Technical Memorandum

Project Name: Snell's Hollow Developers Group - Foundation Drain Volume Estimates

Submitted To: Town of Caledon – Jason Elliott, Senior Planner, Environment – Parks and Natural Heritage

Figure Title
FOUNDATION DRAIN ESTIMATES

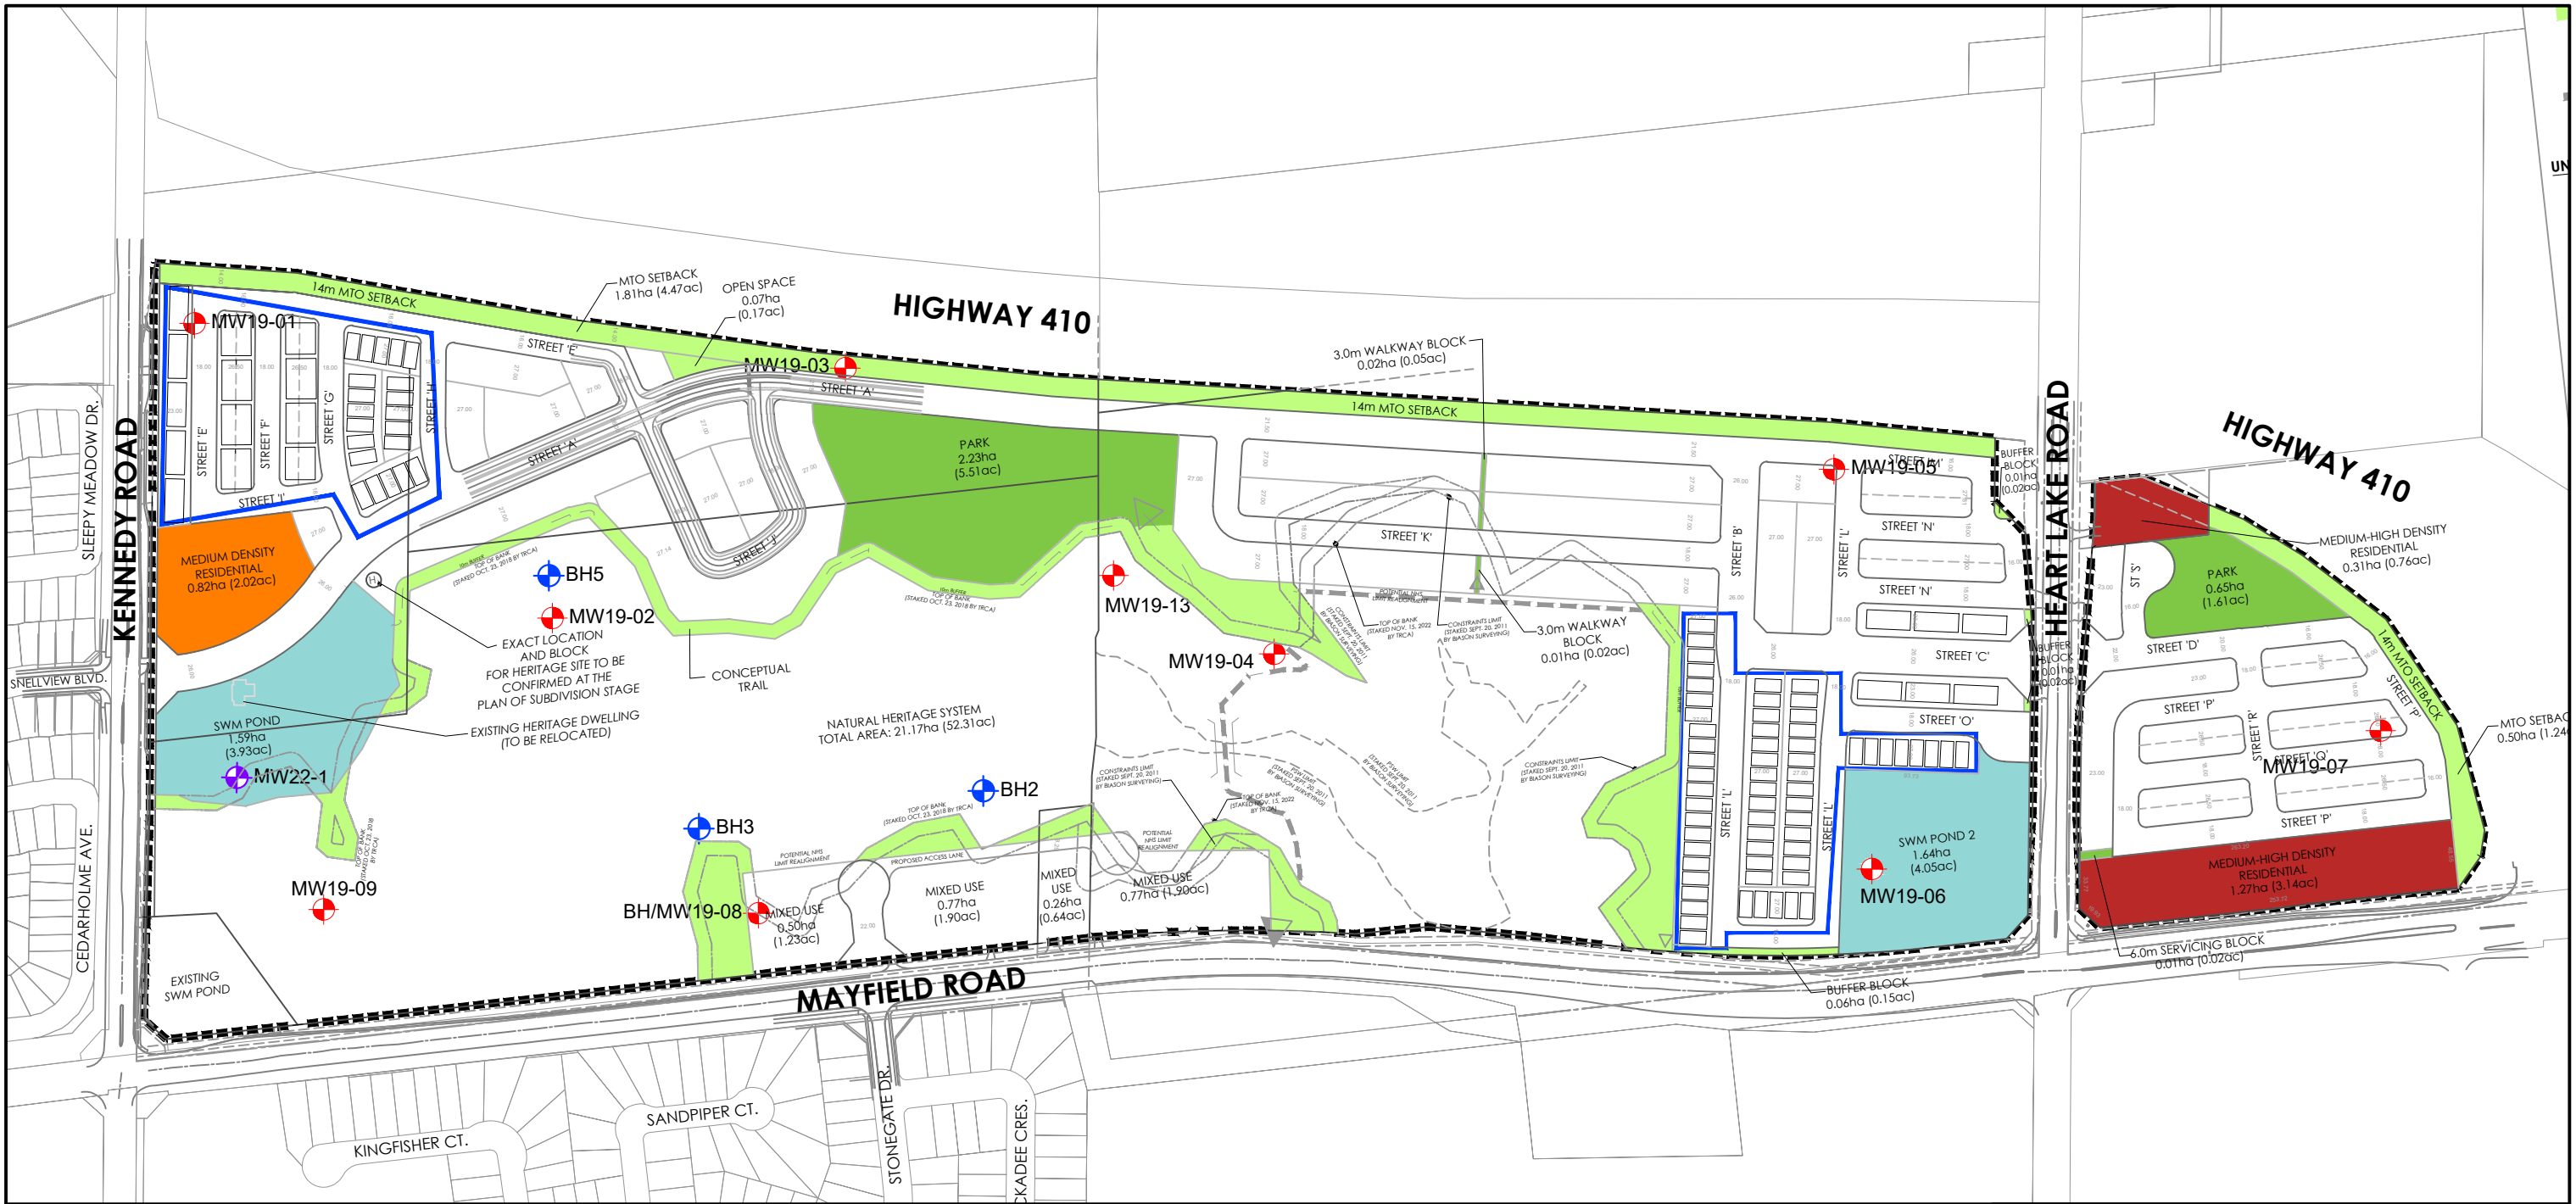
Comment 23: Clarify if/how the proposed sump pumps relate to the site-based water balance (i.e., if they affect the results and/or will intersect groundwater).

An estimate of the foundation drain volumes for the northwest corner of the subject lands and a low-lying area in vicinity of Stormwater Management Pond 2 are further explored below. Refer to Figure 1 for areas of discussion.

As noted above, the seasonal groundwater levels at MW19-01 range from about 1.5 mbgs during the spring freshet to dry conditions (>7.7 mbgs) during the late summer and fall. The total inflow to the foundation drains for the townhouse blocks and single detached dwellings in vicinity of MW19-01 is estimated to be about 31,800 L/day (~0.368 L/sec).

The seasonal groundwater levels at MW19-6, located in vicinity of Stormwater Management Pond 2, have ranged from at surface to about 2 mbgs. The total inflow to the foundation drains for the single detached dwellings is estimated to be about 5,700 L/day (~ 0.066 L/sec).

In review of the groundwater levels across the subject lands, it is interpreted that there are two areas where proposed basements may intersect groundwater; the northwest corner of the subject lands and in vicinity of the proposed SWM Pond 2. Conservative estimates of the annual groundwater discharge to foundation drains from these two areas total 7,884,000 L ($7,884 \text{ m}^3/\text{a}$).

It is concluded that although the foundation drains may encounter groundwater and direct it to the storm system, the estimated infiltration from the proposed stormwater management LID strategy far exceeds what is estimated to be removed by the foundations drains.
